Access Compliance Report Public Rights-of-Way (Curb Ramps)

Main Street: EDINGER_AVE Cross Street: HARBOR_BLV Location: NW

ADA ID: RPRK220222151948 Ramp Type: Type 1 - Perpendicular Diagonal Initial Pass/Fail: Pass Overall Compliance: No Severity Score: 0

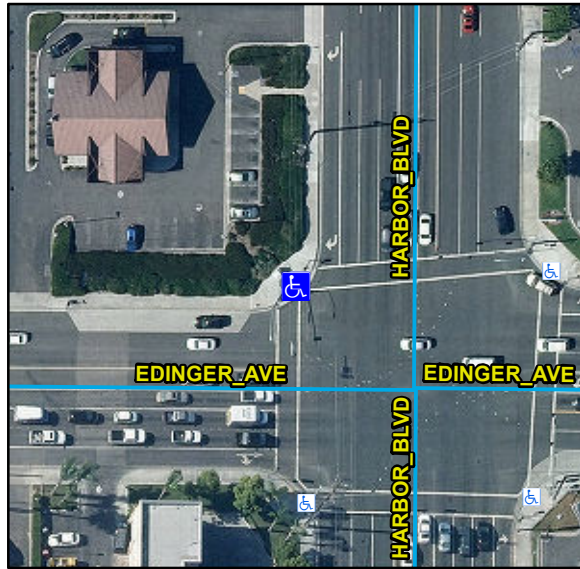
Compliance	Description	Data	Compliance	Description	Data
N/A	Ramp Length (in)	88	N/A	Flare Type LT	
Yes	Ramp Width (in)	48			Sloped
Yes	Ramp Run Slope (%)	3.5	N/A	Flare Slope LT (%)	3.5
Yes	Ramp Cross Slope (%)	0.5	N/A	Flare Traversable LT	No
N/A	Landing Present	Yes	N/A	Flare Type RT	
N/A	Landing Length (in)	54			Sloped
Yes	Landing Width (in)	48	N/A	Flare Slope RT (%)	3.6
Yes	Landing Run Slope (%)	0.5	N/A	Flare Traversable RT	No
Yes	Landing Cross Slope (%)	0.7	Yes	DWS Provided	Yes
N/A	Landing Movement Obstructed?	Yes	Yes	DWS Contrast	Yes
	Landing Movement Type	Curb	Yes	DWS Length (in)	36
N/A	Landing Shared	No	Yes	DWS Full Width	Yes
Yes	Clear Space	Yes	Yes	DWS Offset Left (in)	0
Yes	Clear Space To Crosswalk (in)	48	Yes	DWS Offset Right (in)	N/A
N/A	Marked Crosswalk 1	Yes	N/A	Marked Crosswalk 2	Yes
	Crossing 1 Direction	S		Crossing 2 Direction	E
	Marked Crosswalk 1 Width (in)	144		Marked Crosswalk 2 Width (in)	144

Remove & Replace Landing.

R304.2.1, STD 1115
